# PARTS & SERVICE NEWS

REF NO. AA04083

- SUBJECT:** MODIFICATION OF CAM FOLLOWER ASSEMBLY
- PURPOSE:** To introduce modification procedure to repair cam follower assembly on the 12V 140 Series Engines
- APPLICATION:** HD785-5LC Dump Truck Serial Number A10300 through A10310  
WA800-3LC Wheel Loader Serial Number A50025 through A50028  
WA900-3LC Wheel Loader Serial Number A50021 through A50032  
330M Dump Truck Serial Number A10219  
★ See List of Applicable Engines and Machines
- FAILURE CODE:** A420FF
- DESCRIPTION:** On the 12V140 Series Engines, since the durability margin for various uses has been insufficient, the breakage failure of the roller pin may occur. In case the above mentioned failure has occurred with these engines, make the modification being introduced in this Service News to repair and to prevent the occurrence of the failure.

**NEW PART LISTING**

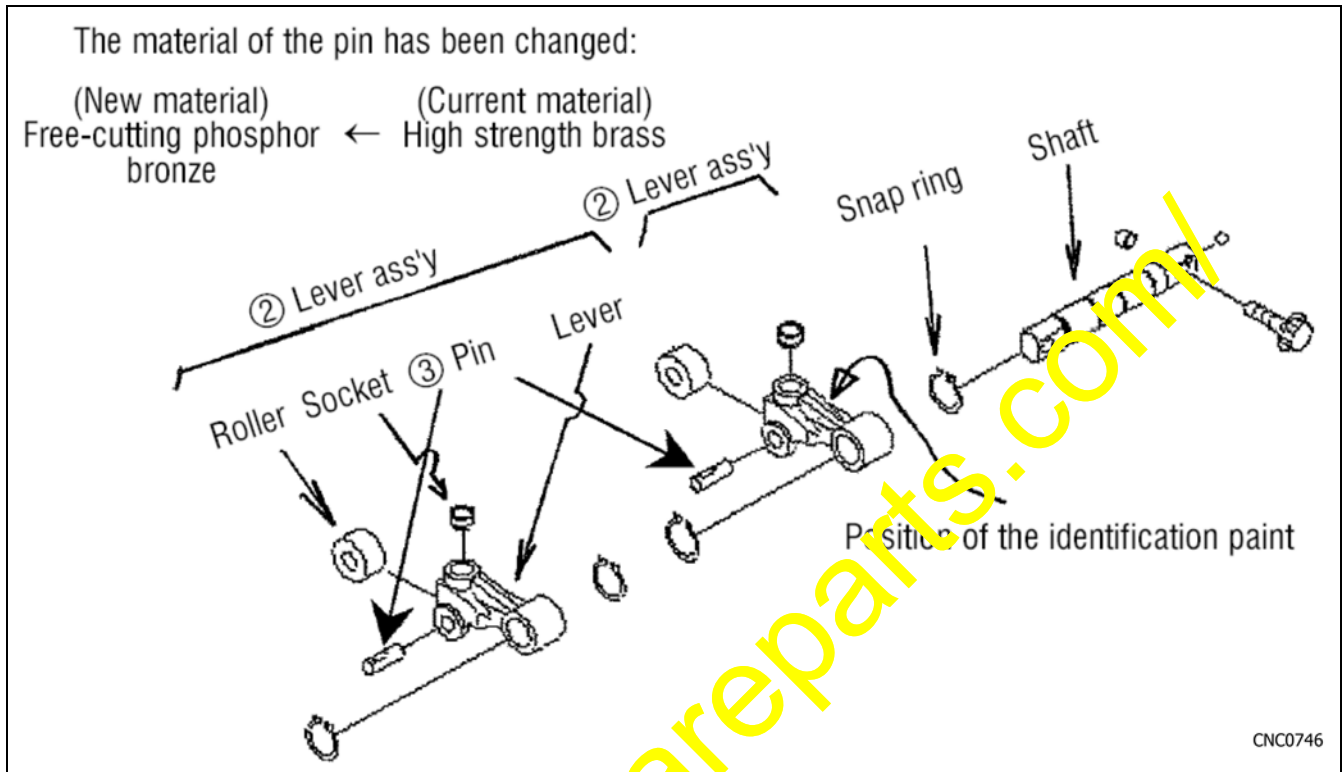
To improve the durability margin against breakage failure of the roller pin, the following modifications have been made. As the pin is changed, the part number of the assembly will also change.

Name	Part Number		Type of drawing
		New	Current	
1	Rocker-shaft assembly ② + Shaft Snap ring	6210-41-2020 Identification paint: Green	6210-41-2011 Identification paint: White or 6210-41-2012 Identification paint: Pink	Rocker assembly  CNC0747
2	Rocker assembly Rocker + Roller Pin Socket	6210-41-2320 Identification paint: Green	6210-41-2301 Identification paint: White or 6210-41-2302 Identification paint: Pink	Rocker  CNC0748
3	Pin	6210-41-2350 Free-cutting phosphor bronze. Pin color: Brown	6210-41-2351 High strength brass Pin color: Yellow	 Pin CNC0749

### ★ Modification history of the lever-shaft assembly and the roller

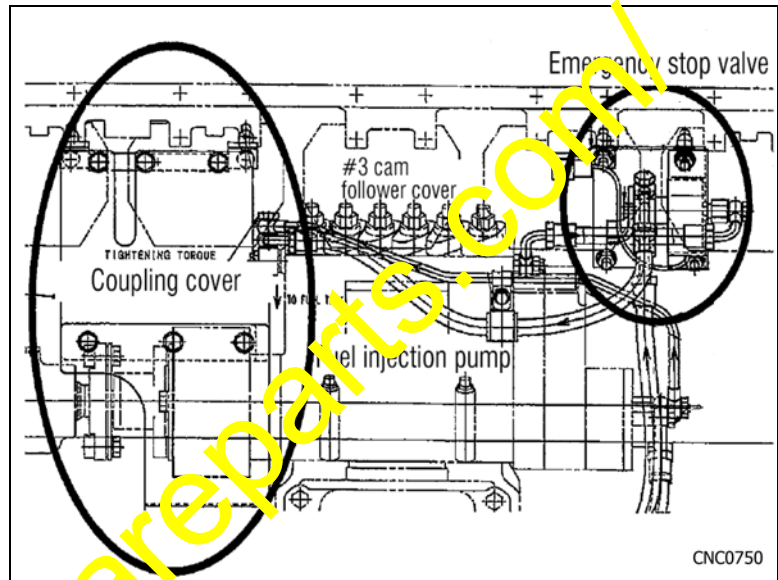
With the roller, 2 stage modifications have been made as shown in the Table (As per No. 2 and No. 3 in the Table) Both of these modifications are for the purpose of improving the durability of the cam shaft and the roller. When replacing the roller separately, use either one of the 6210-41-2341 or 6210-41-2342.

No.	Part of rocker assembly	Roller		Remark
		Part Number	Modification	
1	6210-41-2010	6210-41-2340	—	—
2	6210-41-2011	6210-41-2341	Outer shape The crown has been modified	Improved parts with decreased pressure (Durability of the cam roller has been improved.) (Introduced in Service News "AT02194")
3	6210-41-2012	6210-41-2342	The above No. 2 + The heat treatment has been changed.	In comparison with the above No. 2, the durability of the cam roller has been further improved.
4	6210-41-2020	6210-41-2342	The above No. 2 + The heat treatment has been changed.	The roller is the same as the above No. 3. (Material change has been made with the pin only.)
